STONE HOUSE - 1050 E WASHINGTON AVE

UTILITIES ONLY

CITY PROJECT NO. 12592

CITY CONTRACT NO. 8385

C200

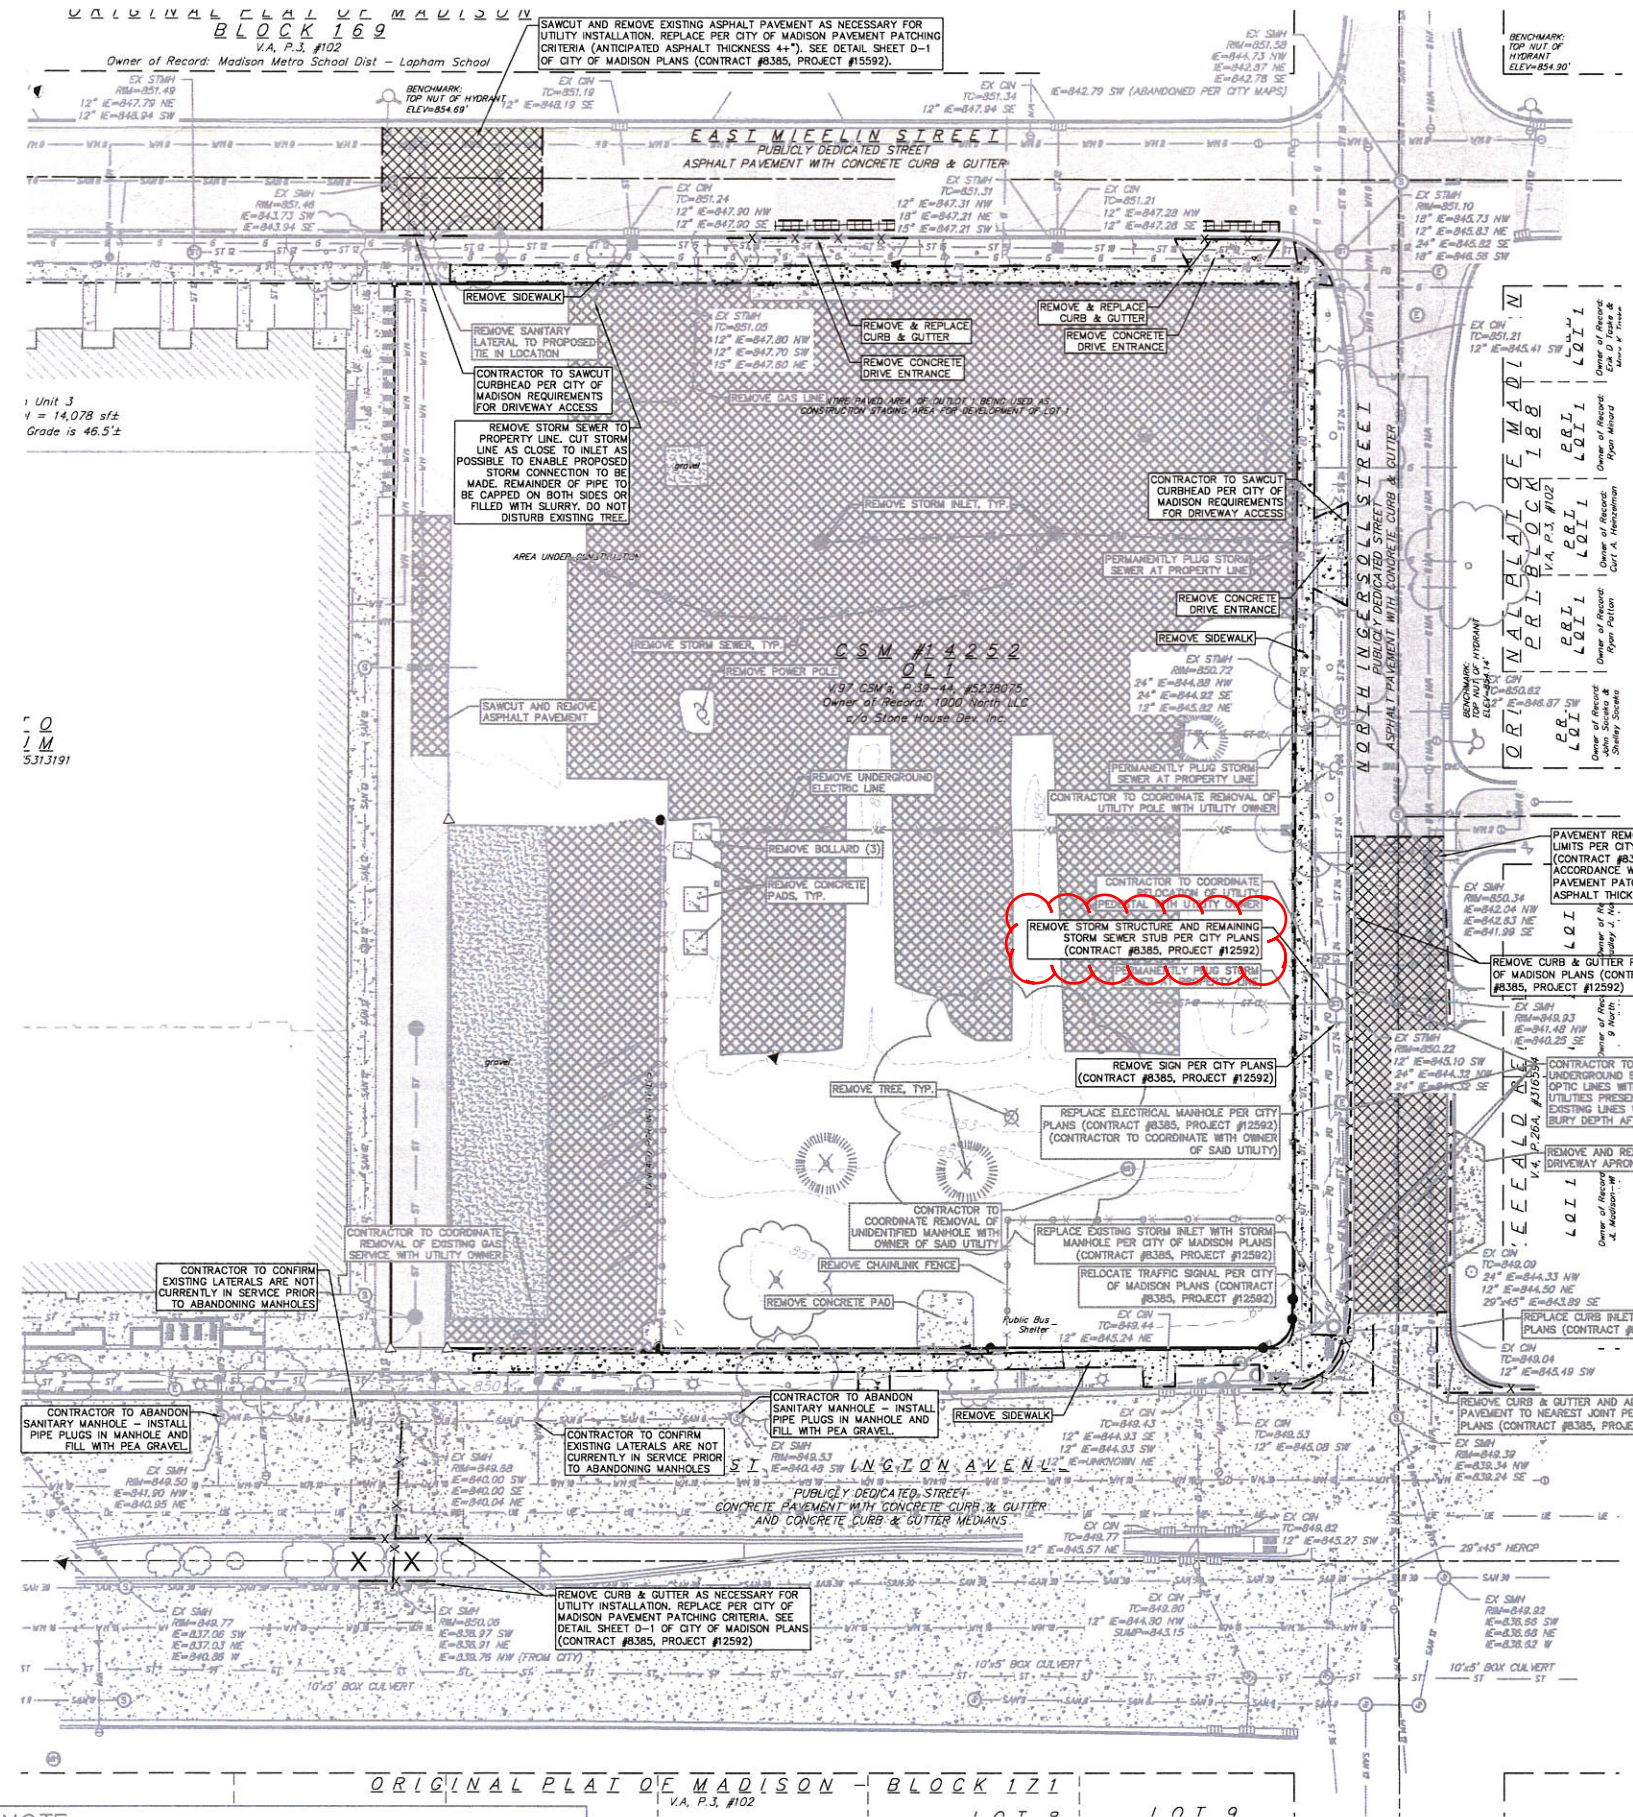
REV BY AJC 2019-10-04
NOTE CHANGE TO CLARIFY
REMOVAL OF STORM STRUCTURE
AND REMAINING STUB.

C600

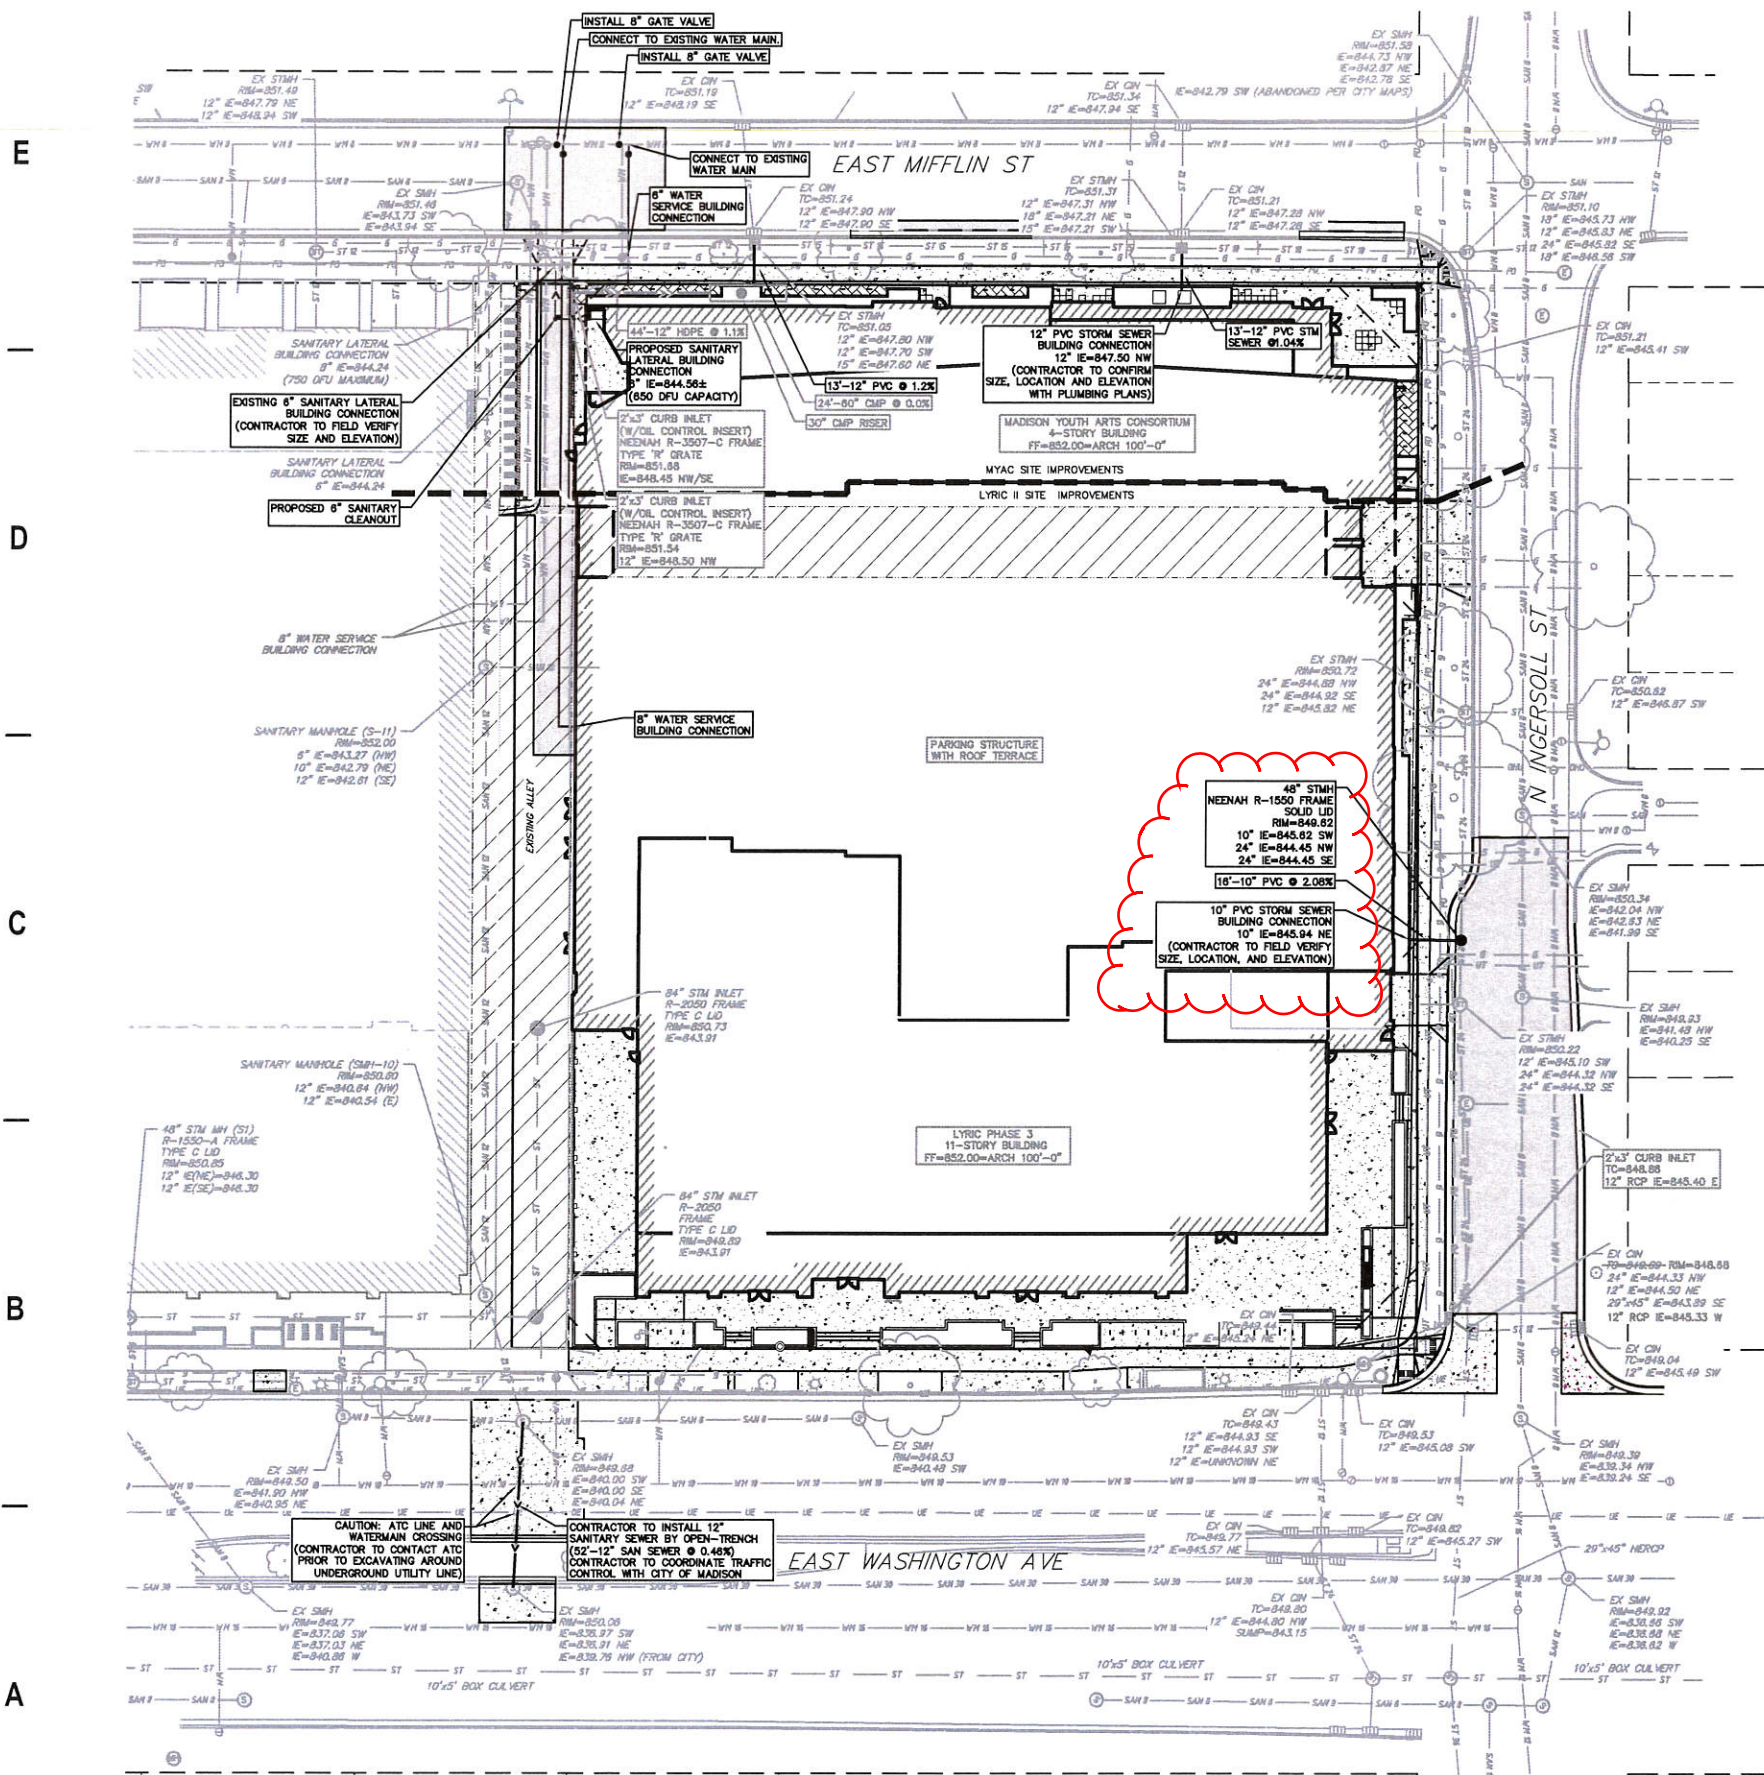
REV BY AJC 2019-10-04
CHANGED RIM ELEVATION FOR PROPOSED STORM MANHOLE.
